000 91 13.2 – ADDENDUM NO. 2

- A. Project Name: Pacific Building Conversion
- B. Owner: Kitsap County Department of Human Services
- C. Architect: Rice Fergus Miller, Inc.
- D. Architect Project Number: 2021056.01
- E. Date of Addendum: November 29, 2023

M22.01

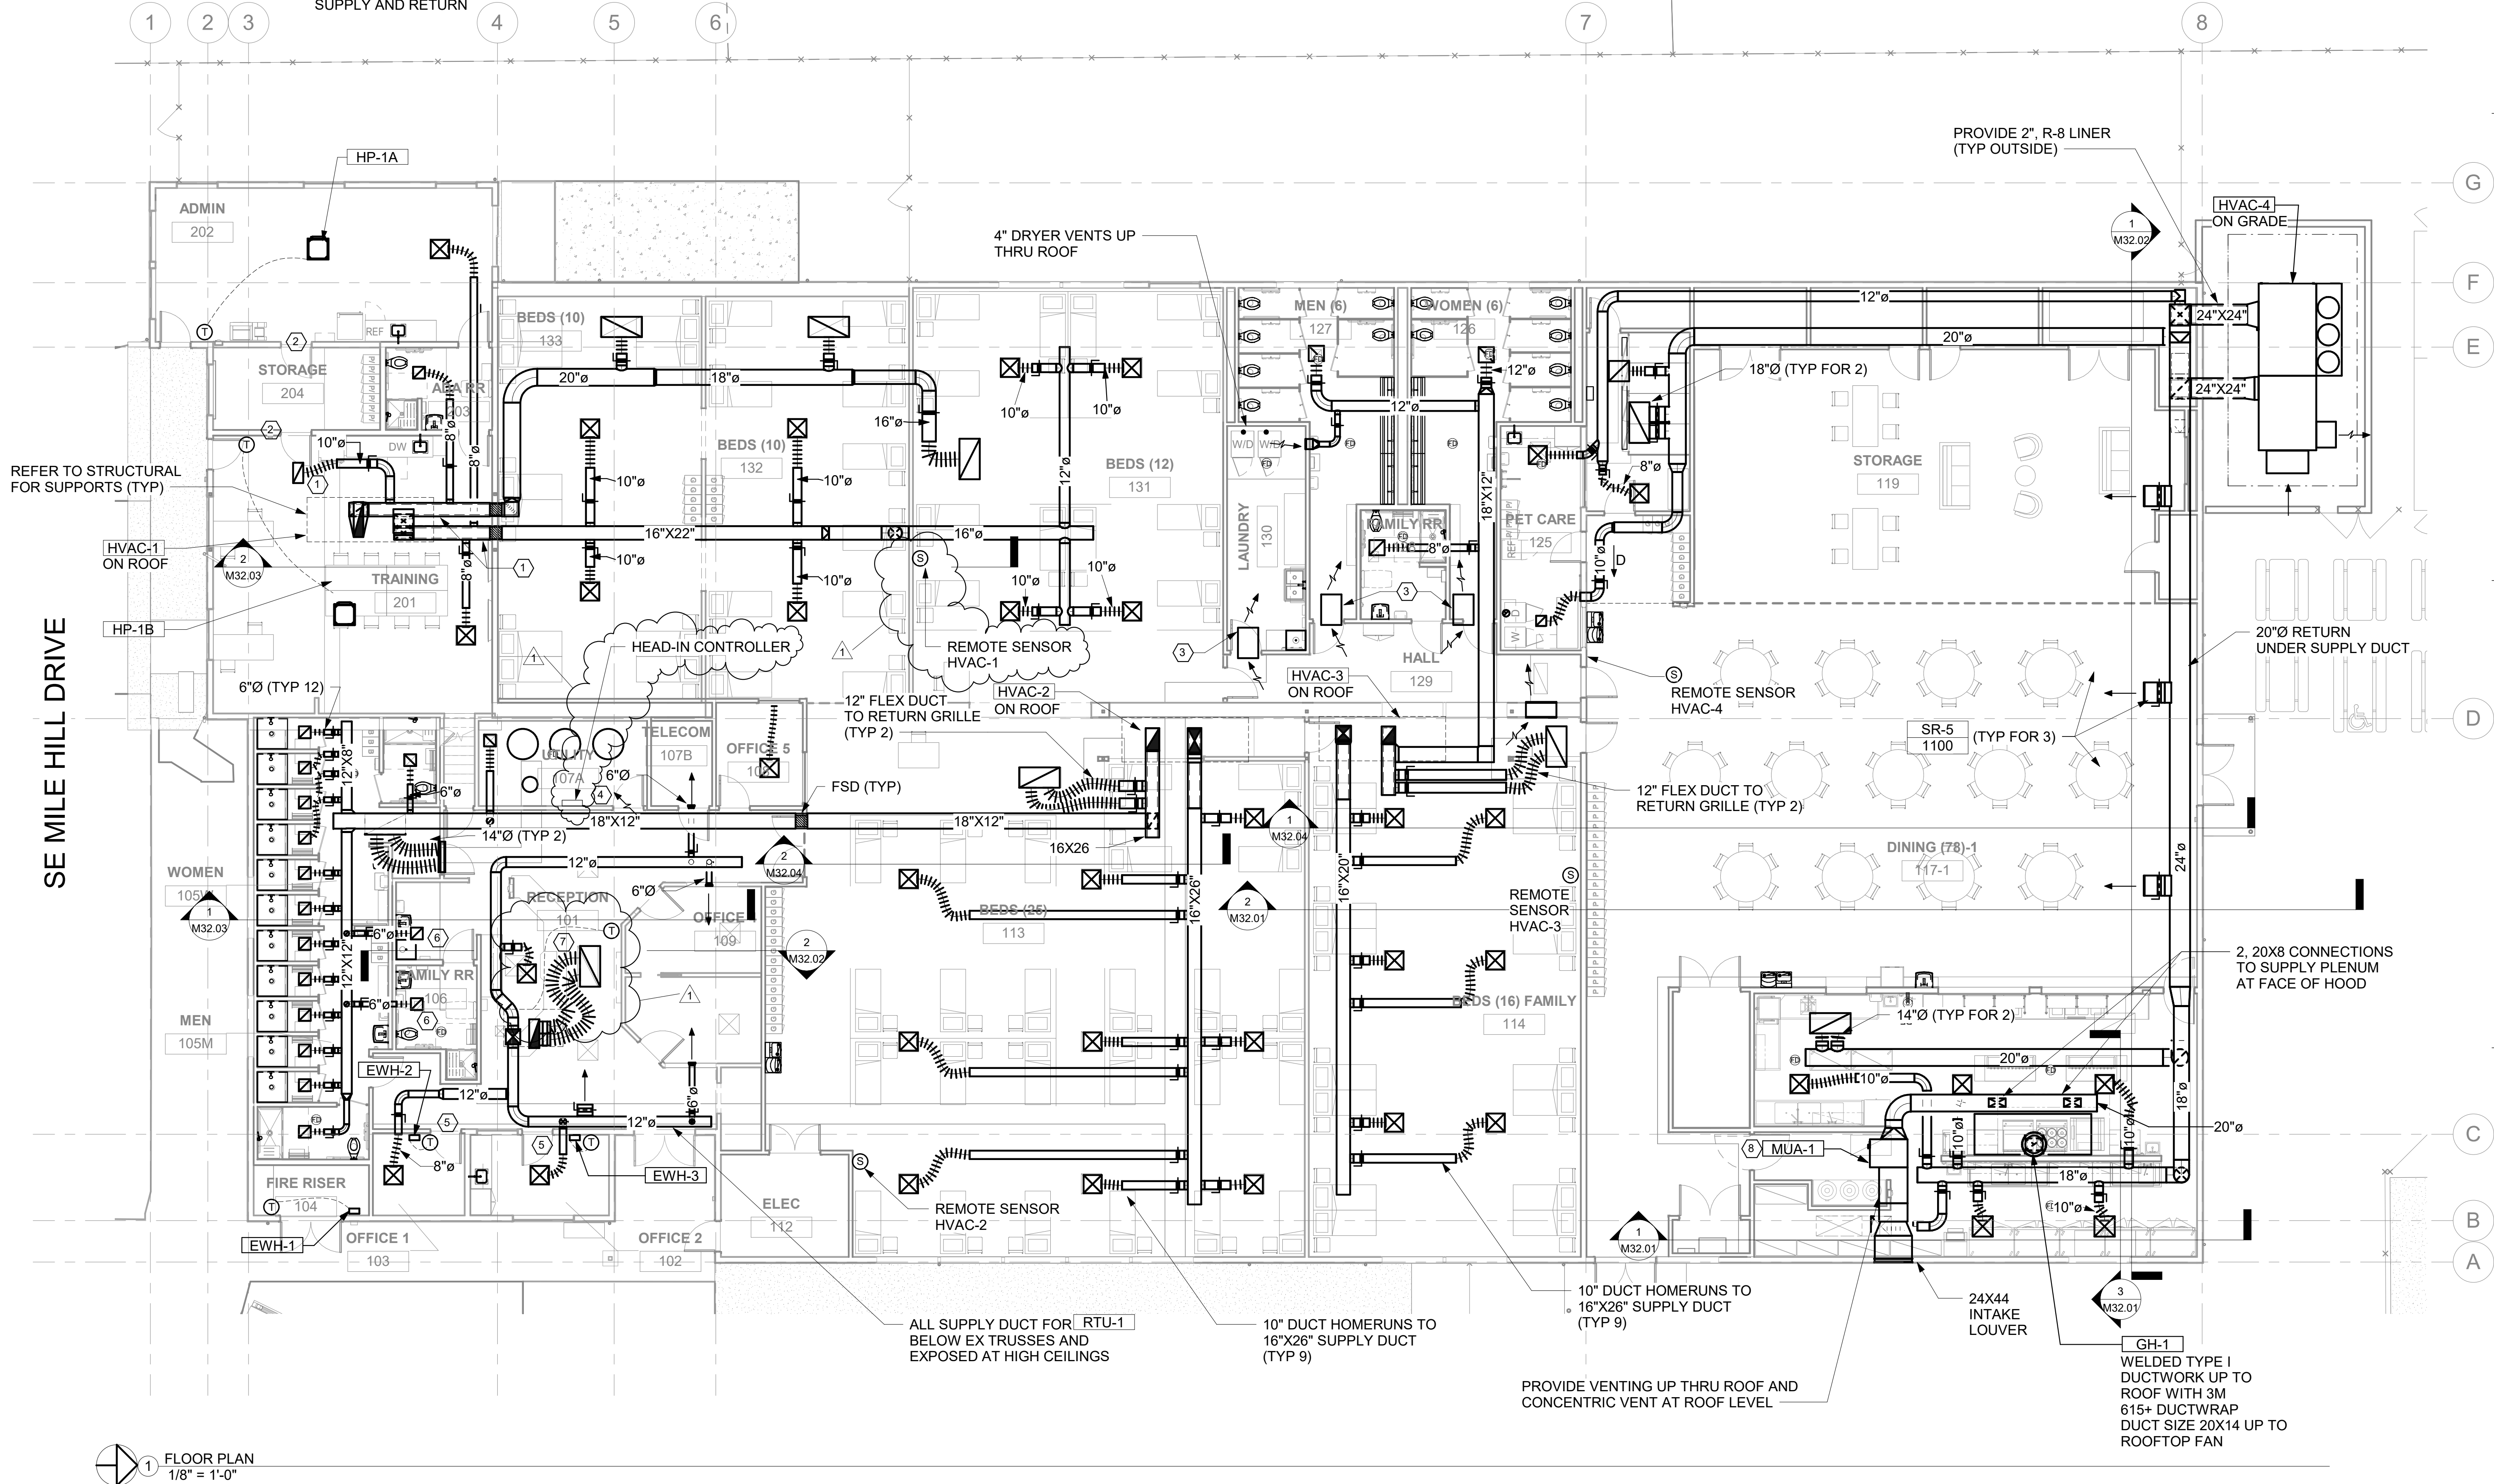
- ITEM 13. Sheet M22.01 – REPLACE in its entirety:
- a. RTU-1 thermostat located added. HVAC-1 remote sensor located added. Central controller added.
- ITEM 14. Sheet M33.04 – REPLACE in its entirety:

2
M33.04 SCALE: N.T.S.

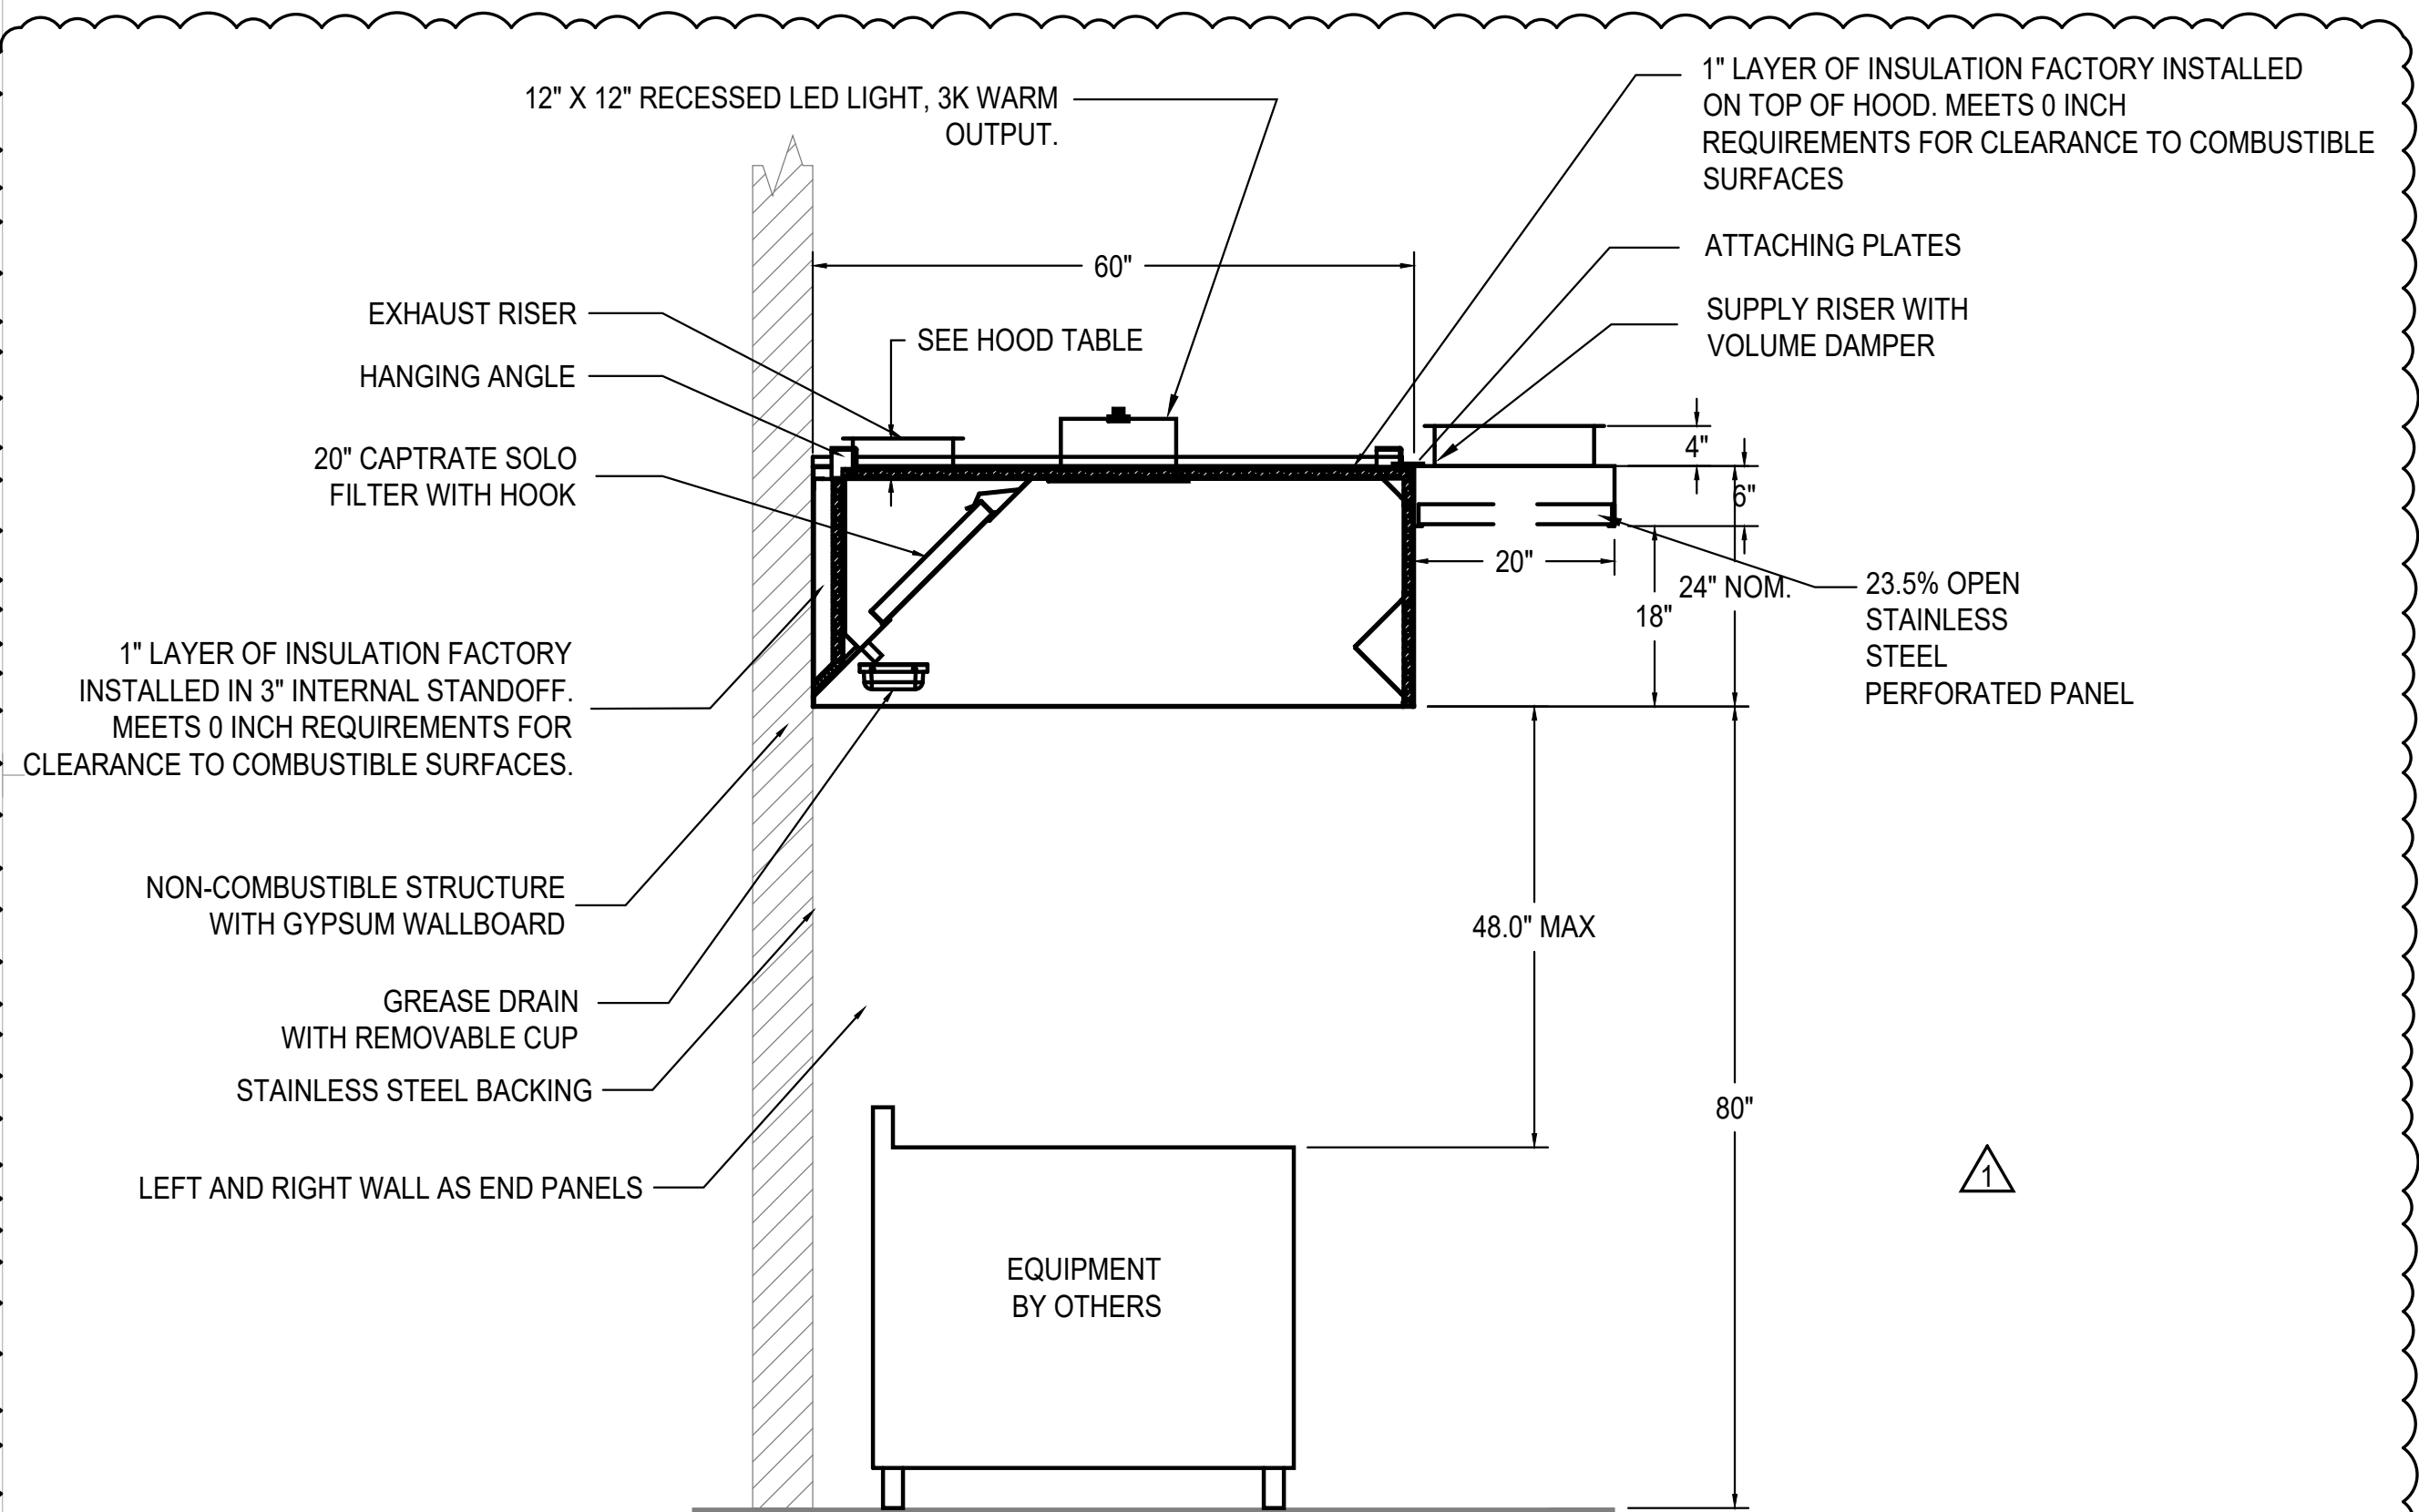
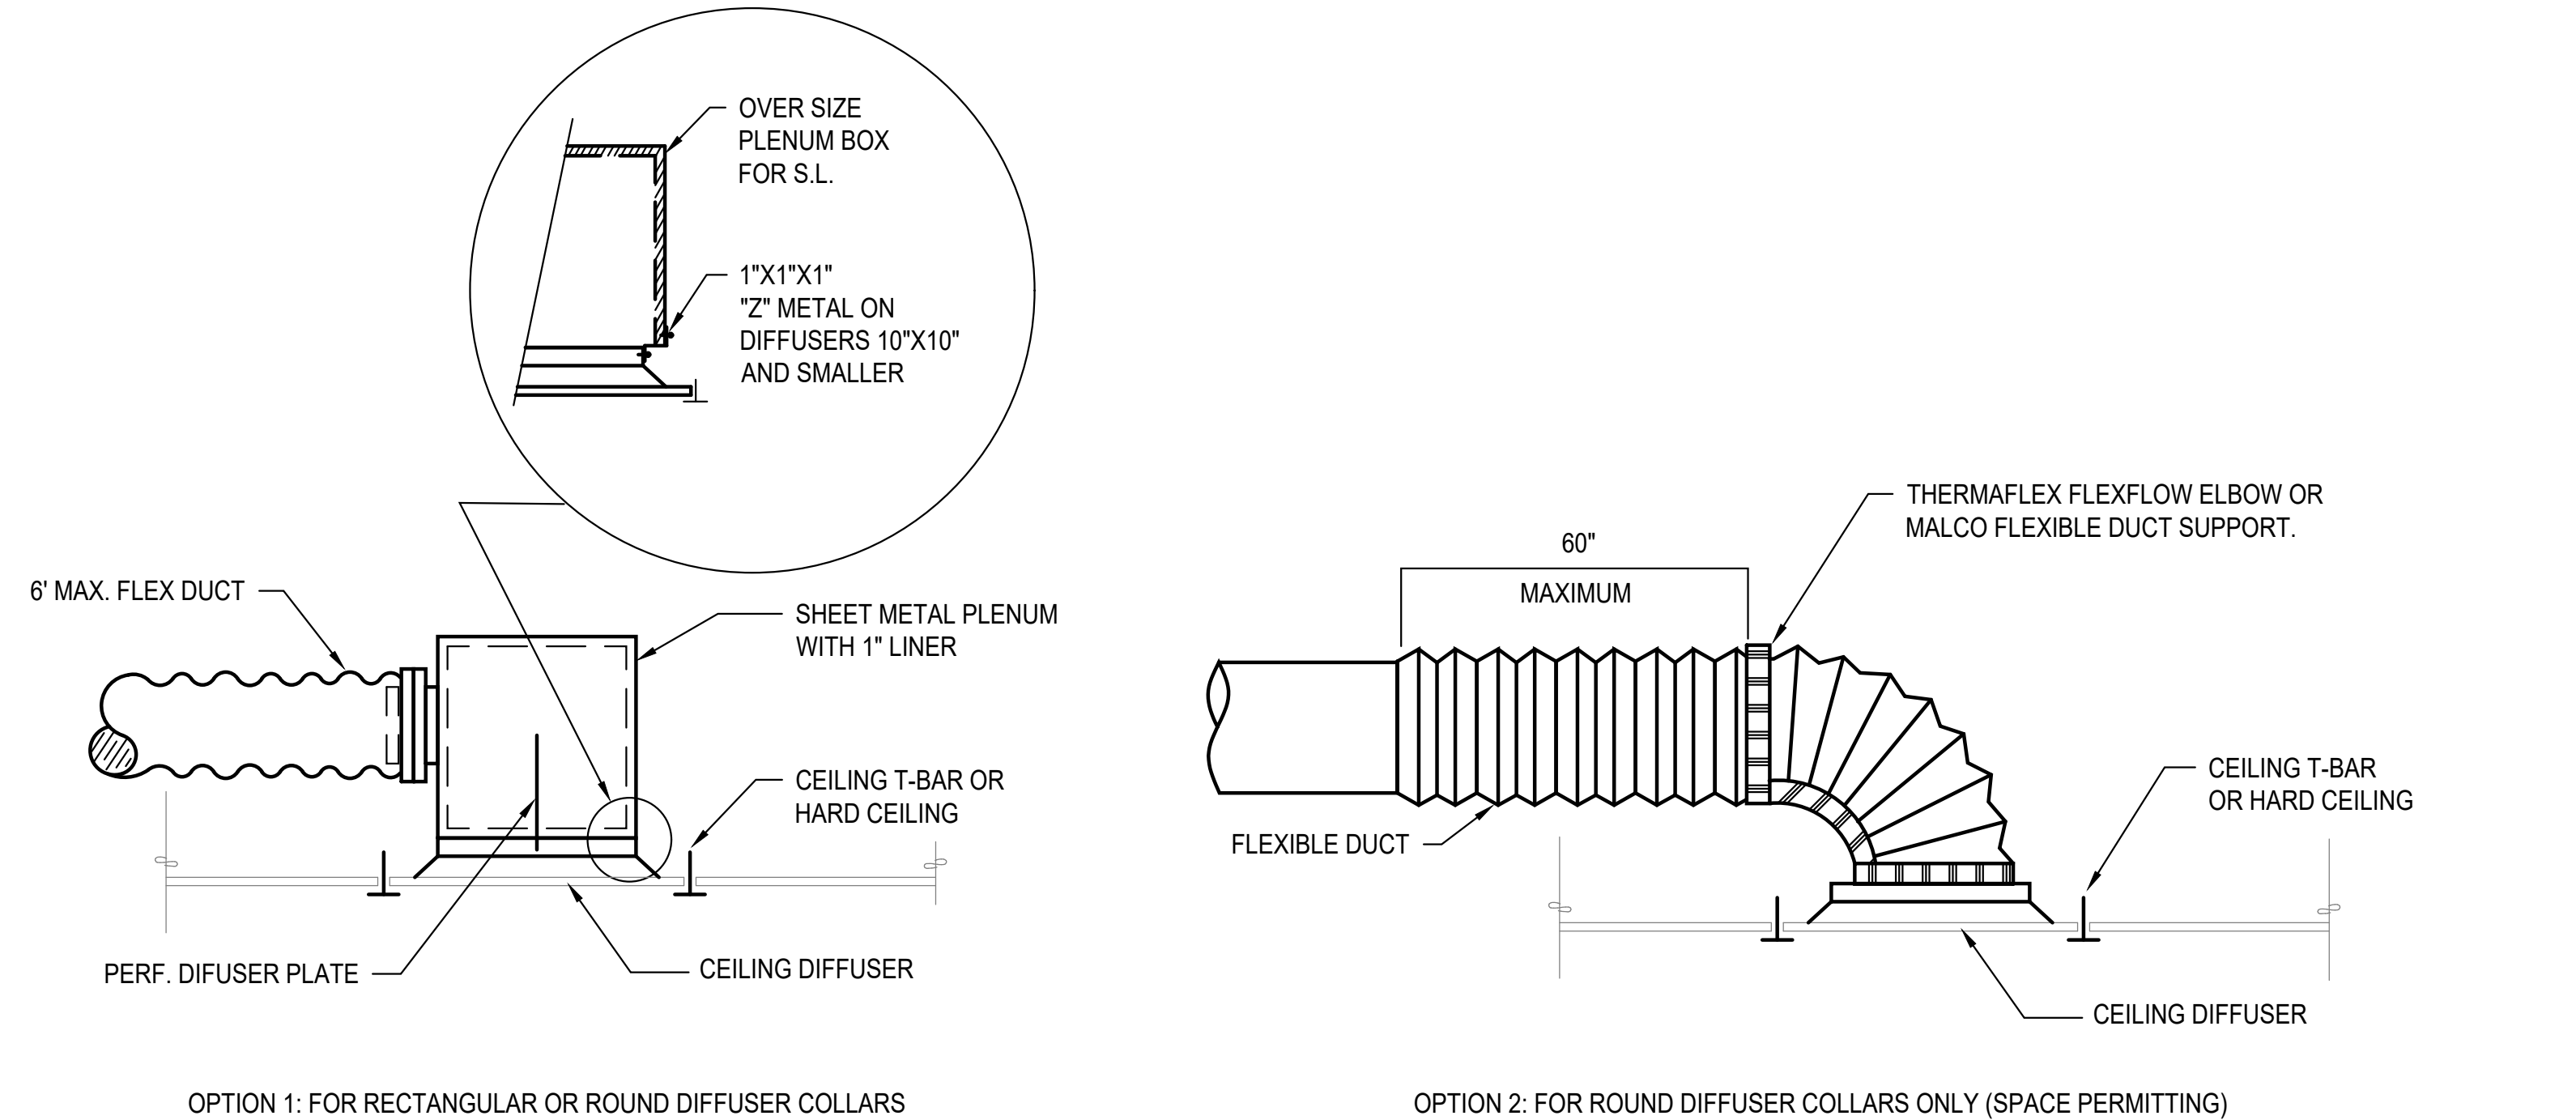
- a. Detail 2 replaced. Detail 3 added.
- ITEM 15. Sheet M42.00 – REPLACE in its entirety:
- a. DSB diagram updated with controls.
- ITEM 16. Sheet P22.00 – REPLACE in its entirety:
